LHCLJ 4U0009

Installation Layouts at Point 4, 3D Integration		EHELLE SCALE 1:20	DES/DRA.	C. MAGNIER	2003-09-01
TUNNEL RB46 TOP VIEW AND SECTIONS TUNNEL RB46 VUE DE DESSUS ET COUPES			CONTROLLED	Y. MUTTONI	2007-09-04
		RELEASED	S. CHEMLI	2007-09-07	
		APPROVED	-	-	
LHCLJ_LJ_4U_3DINTP4-000_L030_L0302113PL					
REPLACE/REPLACES					
CERN	RELEASED BY	FOR	QAC	SIZE	IND.
	PROJECT ENGINEER	INFORMATION	-		
LHCLJ_4U0009				0	C

BGC_PT4 RIGHT_FPILLON

ASSEMBLY LHC BG CAB0041

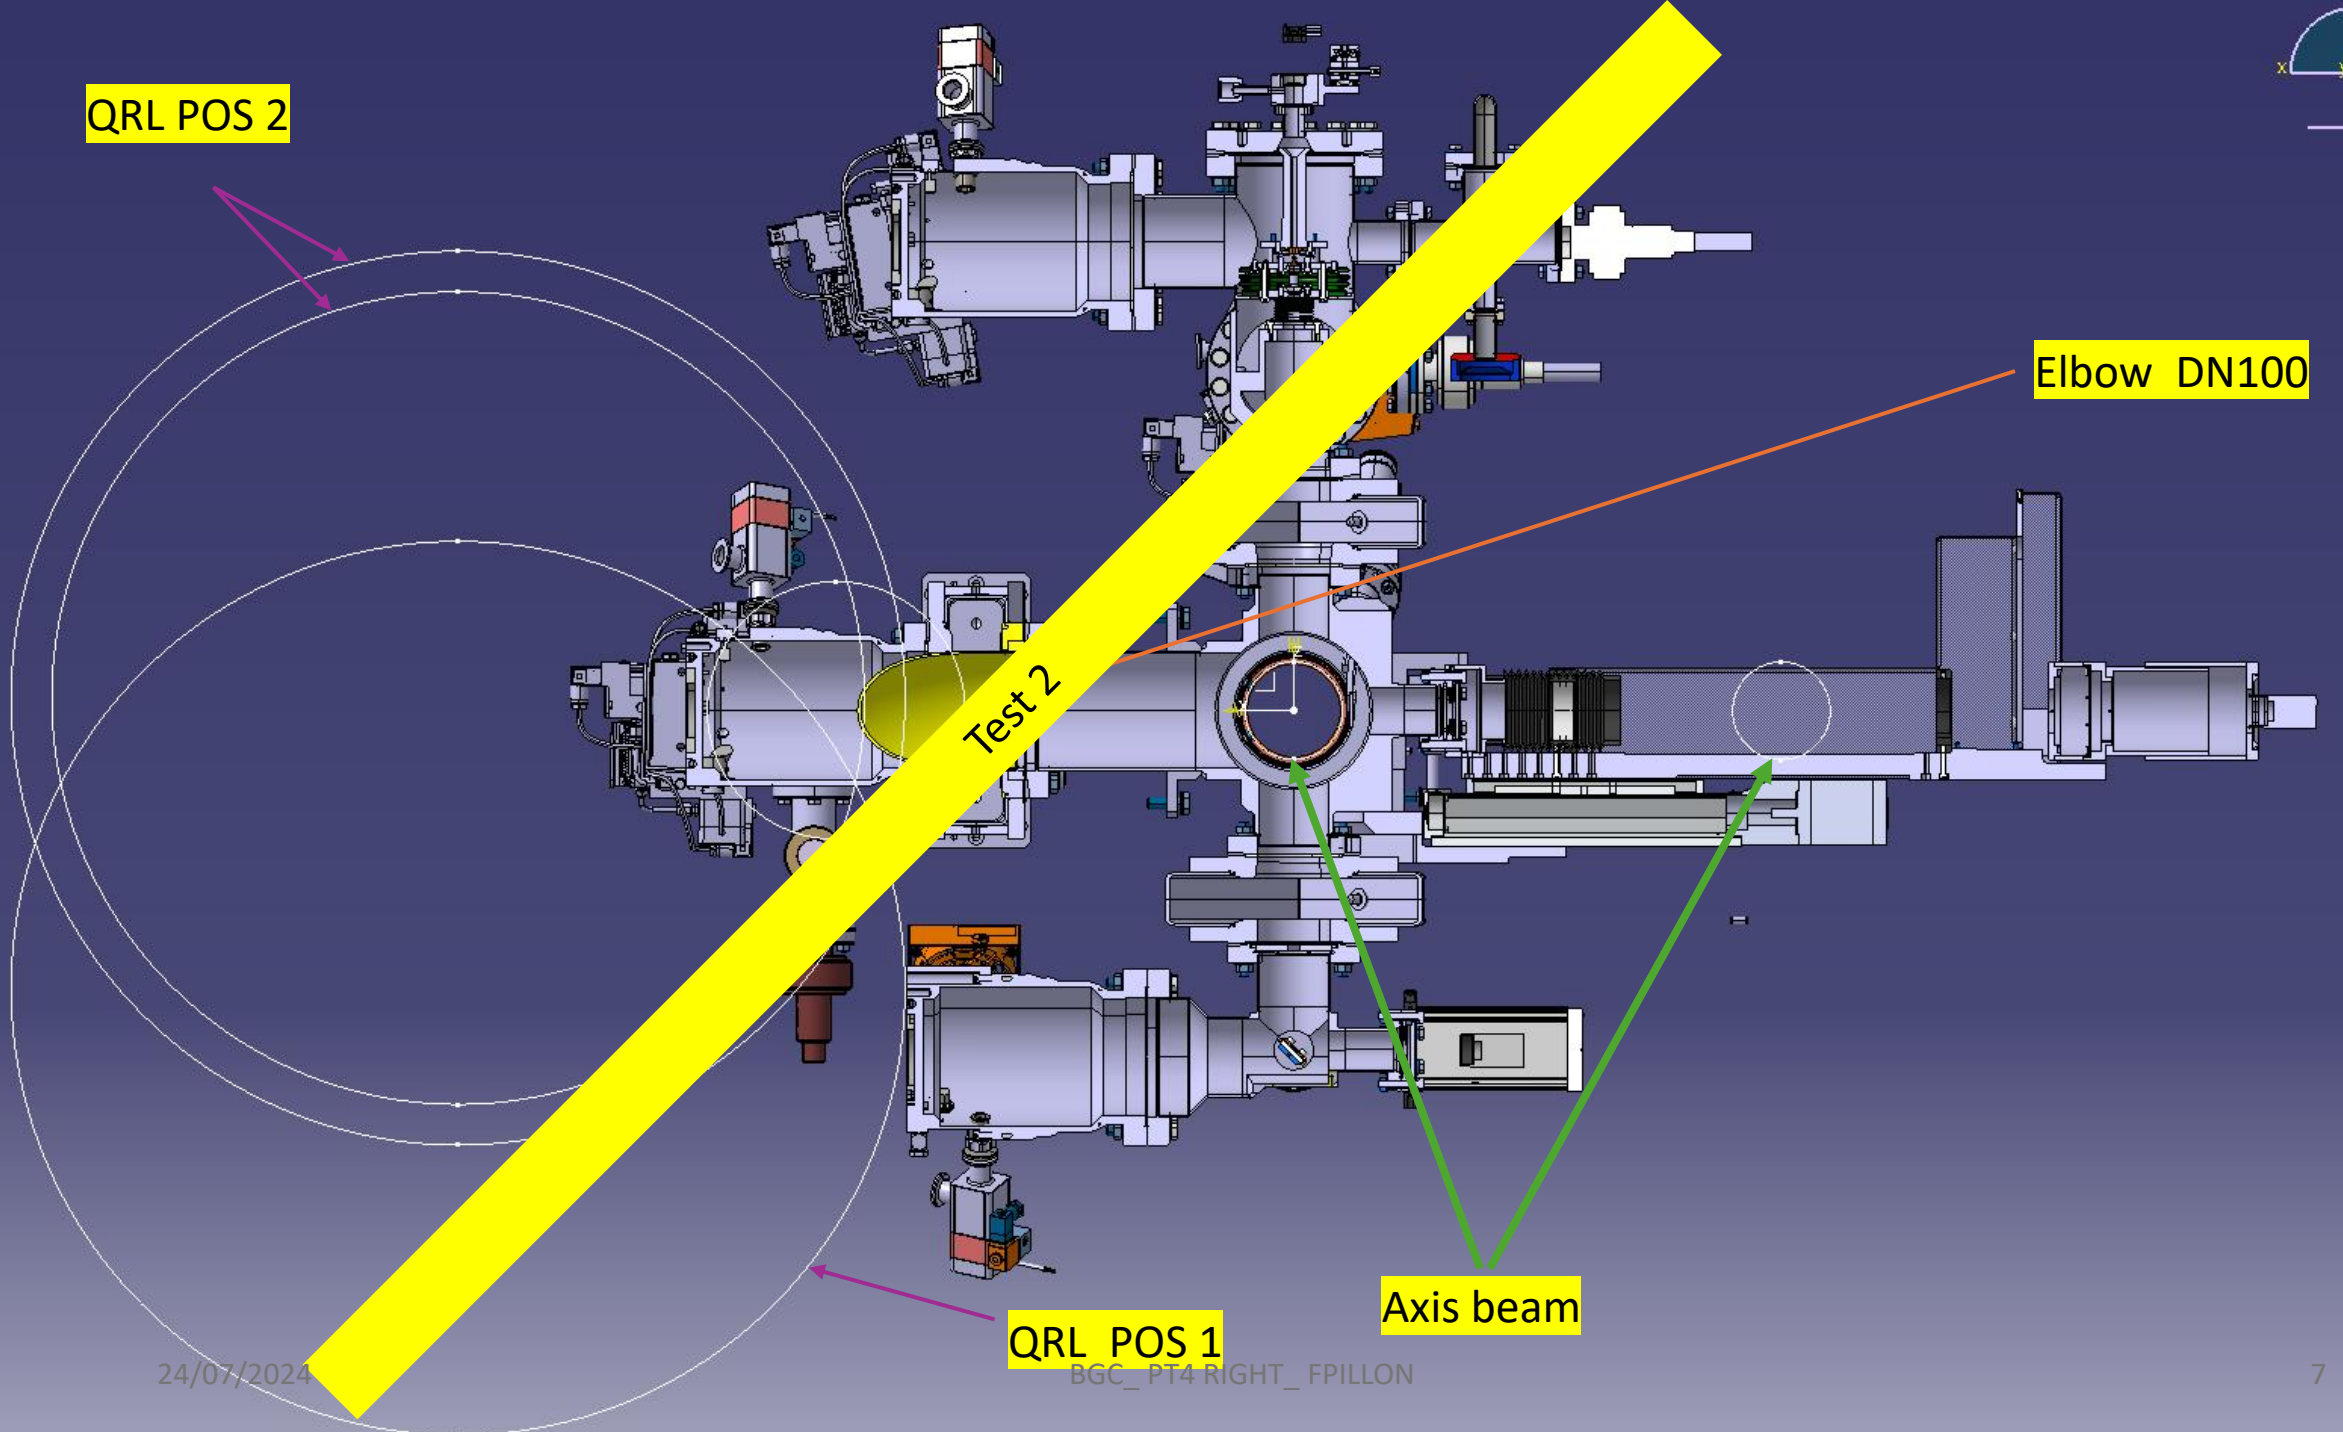
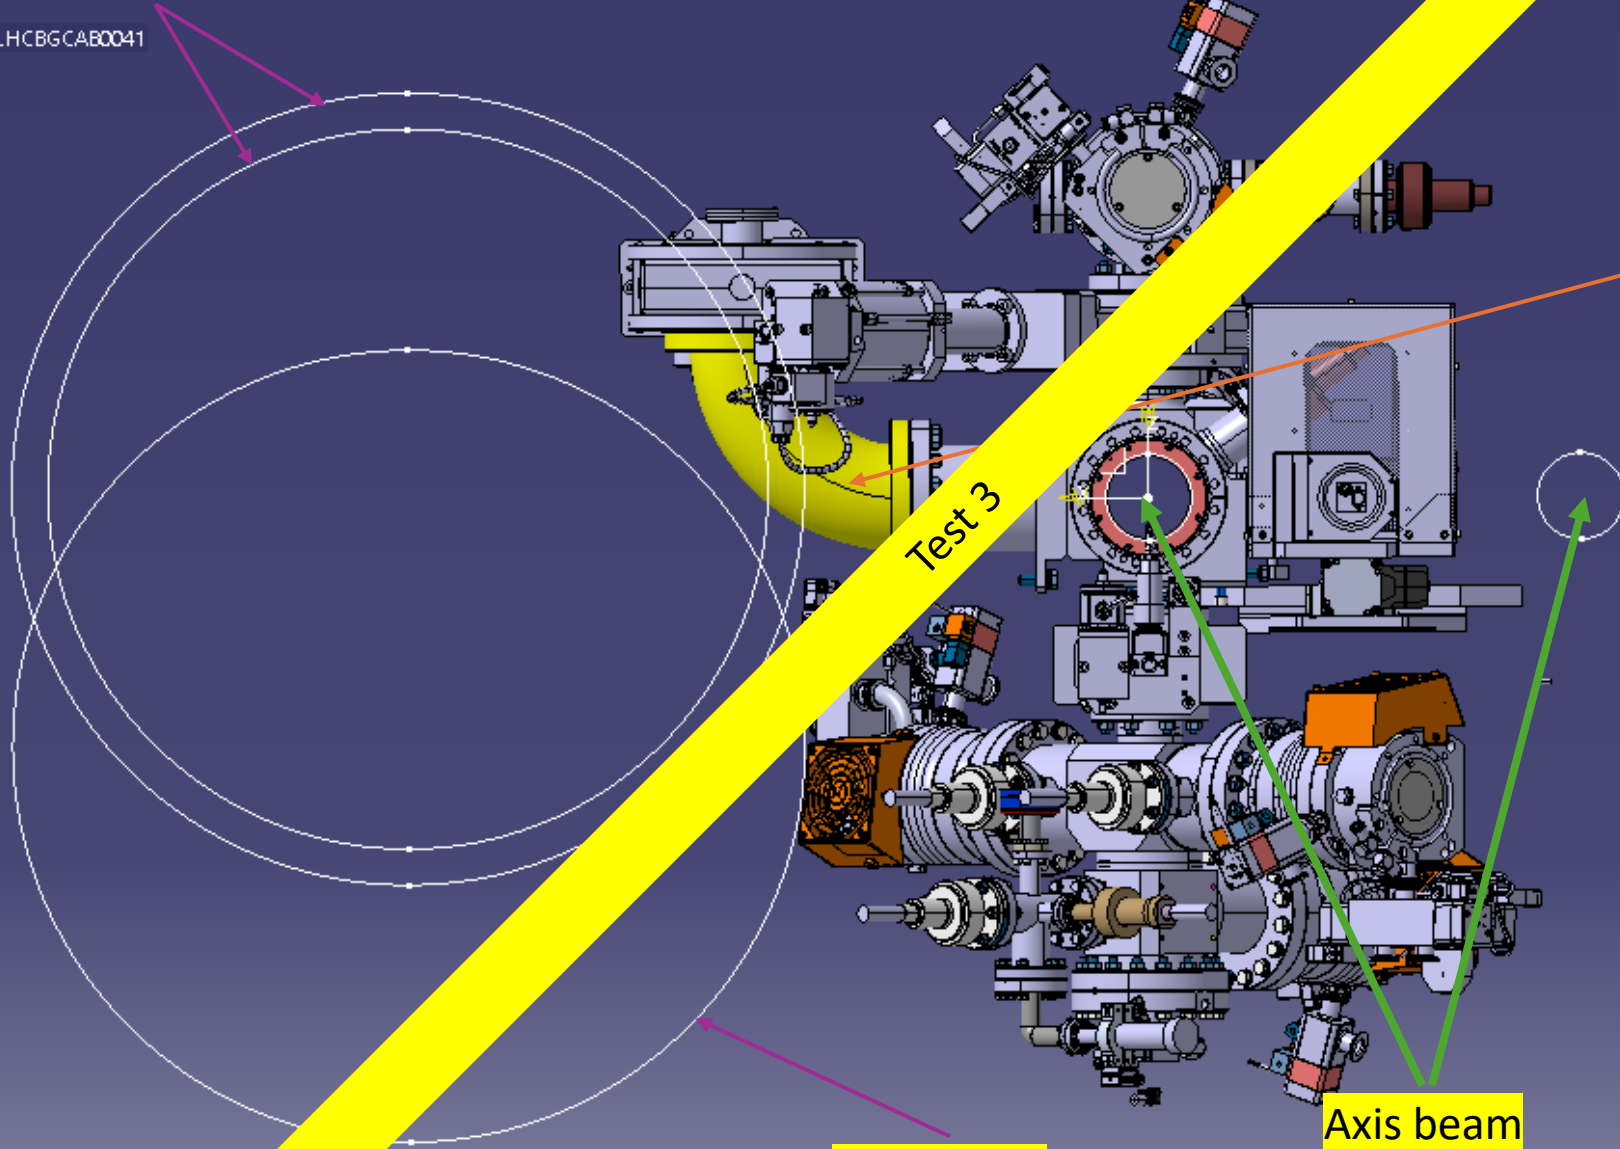
1. Integration with Scan , Valve DN100 / QRL 21.7 mm spacing it's, ok ? (see slide 9)
2. **Turbo Molecular Pump DN100_ mounting and dismounting? (see slide 9)
3. DN 63 valves, actuator instrumentation can be rotated 180 degrees? (see slide 10)
4. Camera Assy ,turned 90 degrees possibility ?
